**SUNDRY NOTICES AND REPORTS ON WELLS**  
*Do not use this form for proposals to drill or to re-enter an abandoned well. Use Form 3160-3 (APD) for such proposals.*

1. Type of Well <input checked="" type="checkbox"/> Oil Well <input type="checkbox"/> Gas Well <input checked="" type="checkbox"/> Other <i>injection</i>	5. Lease Serial No. <b>NM 24490</b>
2. Name of Operator <b>EOG Resources, Inc.</b>	6. If Indian, Allottee or Tribe Name
3a. Address <b>PO Box 2267, Midland, TX 79702</b>	7. If Unit of CA/Agreement, Name and/or No. <b>Red Hills North Unit</b>
3b. Phone No. (include area code) <b>432-686-3389</b>	8. Well Name and No. <b>Red Hills North Unit #807</b>
4. Location of Well (Footage, Sec., T., R., M., or Survey Description) <b>99N FSL 330 FWL, Sec 18-T25S-R34E 32.1259613 -103.5164185</b>	9. API Well No. <b>30-025-34659</b>
	10. Field and Pool, or Exploratory Area <b>Red Hills, Bone Spring</b>
	11. County or Parish, State <b>Lea County, NM</b>

**RHNU #807**  
 API# 30-025-34659  
 Sect 18, T2SS, R34E  
 SHL: 990' FSL & 330' FWL, BHL: 000' FNL, 000' FEL  
 Eddy County, NM

**Permanent Abandonment of Federal Wells**  
**Conditions of Approval (LPC Habitat)**

RHNU #807  
 API# 30-025-34659  
 Sect 18, T255, R34E  
 SHL: 990' ESL & 330' FWL, BHL: 000' FNL, 000' TEL  
 Eddy County, NM

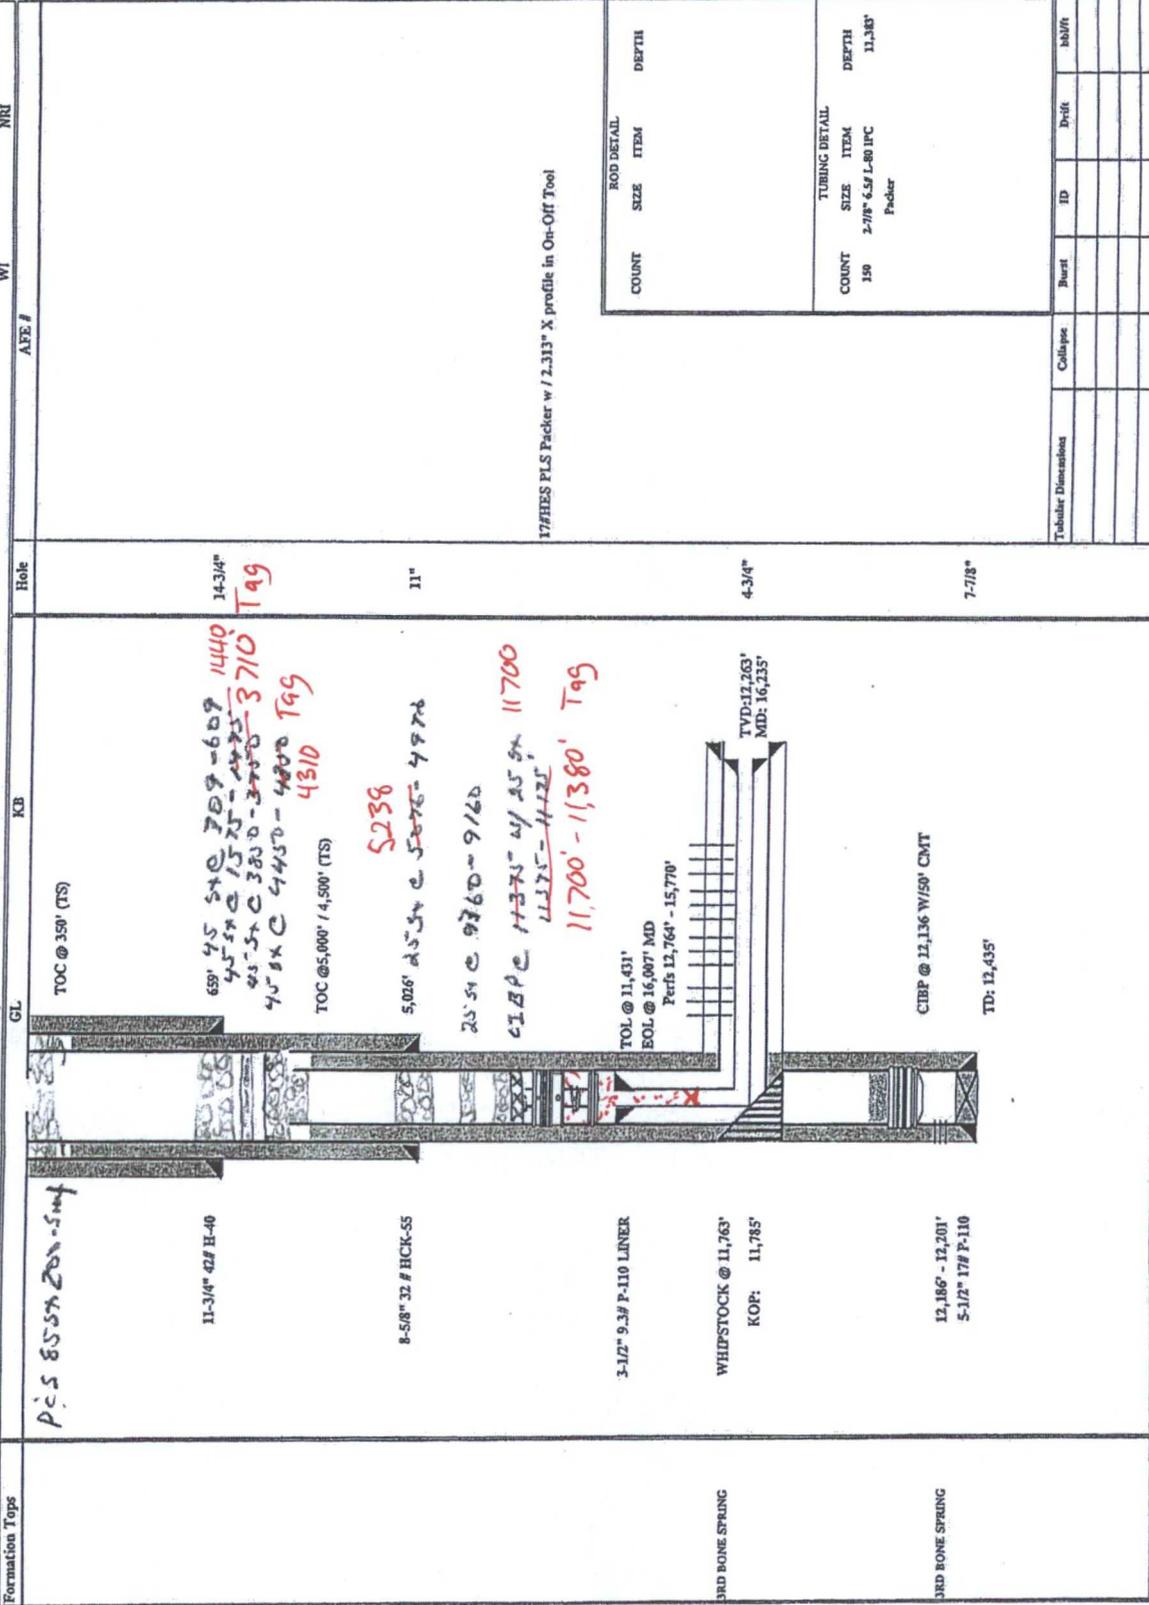
- Un-latch on/off tool and POH w/ 11383' tbg.
- Set 5 1/2 CIBP @ 11375. Circulate hole w/ mud laden fluid. *11700'*
- Spot 25 sx cement @ 11375-11175. *11700 - 11360' woc + tag (Liner top)*
- Spot 25 sx cement @ 9360-9160. (BS)
- Spot 25 sx cement @ 5076-4976. (Shoe) Tag *(T. Del) 5238'*
- Cut and POH 5 1/2 csg @ 4400'.
- Spot 45 sx cement @ 4450-4350. (stub). *(Tag) 4310*
- Spot 45 sx cement @ 3850-3750. (Btm salt) *3710' Tag*
- Spot 45 sx cement @ 1575-1475. (Top salt) Tag *1440*
- Spot 45 sx cement @ 709-609. (shoe) Tag.
- Perf and Sqz 85 sx @ 200-surface.
- Cut off wellhead and weld on Dry Hole Marker.

*P.S. 85574 200-544*
